TECHNICAL BULLETIN
LTB00630NAS1
04 FEB 2014

Front Floor Console Cup Holder Sliding Cover Does Not Latch / Sticks in the Open Position

Range Rover (LG)

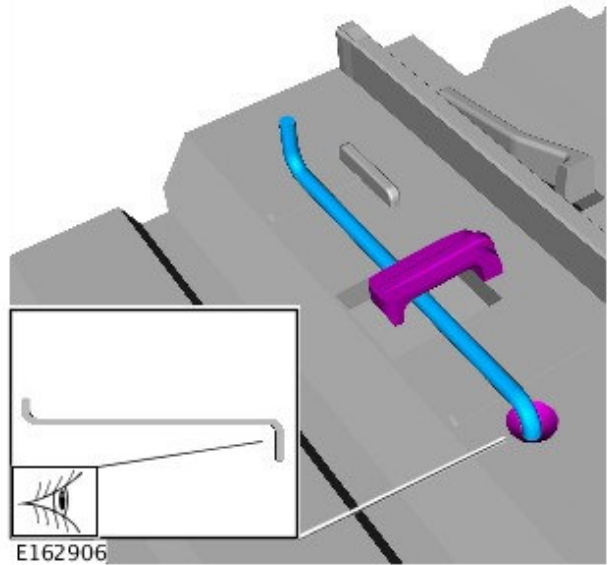
12.  **CAUTION: Note the location of the spring for installation.**

Remove the spring.

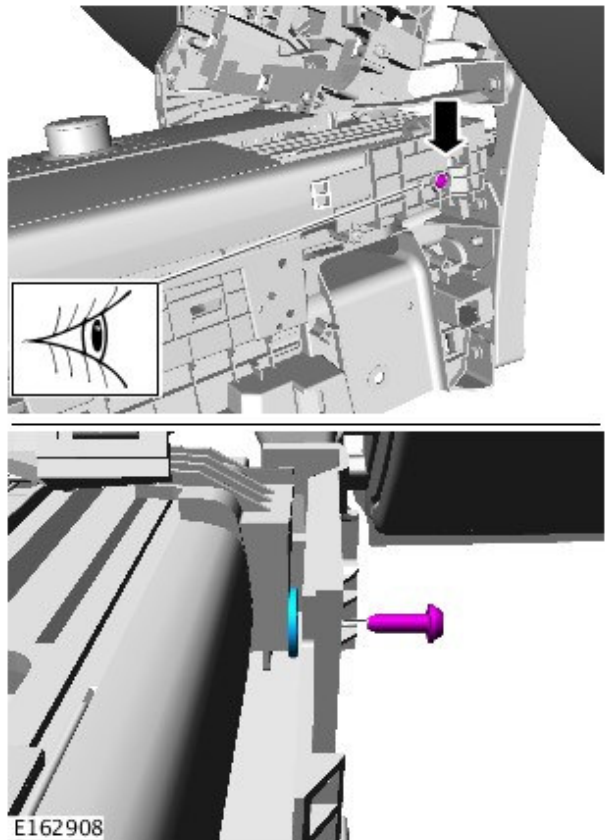
13. Install the washer from the Service Kit:

- Remove the Torx screw;
- Install the washer;
- Install the Torx screw; tighten to 3Nm.
